REF NO.	AT01256
DATE	Feb. 15, 2002

SUBJECT: IMPROVED HYDRAULIC CIRCUIT BLOCK AGAINST OIL LEAKAGE ON WA1200-3

APPLICATION: WA1200-3 Wheel Loaders, Serial Nos. 50007 thru 50011

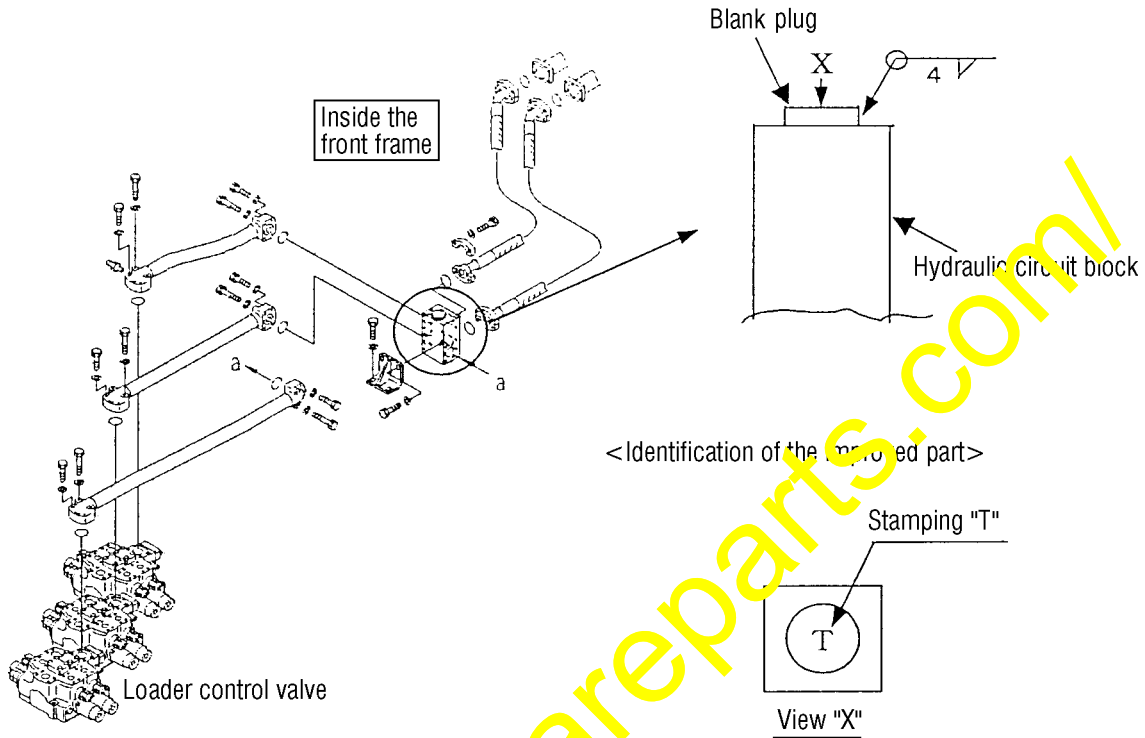
Since there is a possibility of occurrence of oil leakage through the welded section of the blank plug on the hydraulic circuit block for the return line from the work equipment on WA1200-3 wheel loaders, implement the modification being introduced in this Service News to prevent occurrence of the aforesaid trouble.

To prevent occurrence of cracks in the welded section, the material for the blank plug for the hydraulic circuit block has been changed.

(Since blank plugs made of wrong material has been mixed to the blank plug supply.)

- Replace the hydraulic circuit block shown in the above drawing to the supplied part 42C-62-13911 (with the stamping "T")
- Locally abolish the hydraulic circuit block which has been removed for replacement.
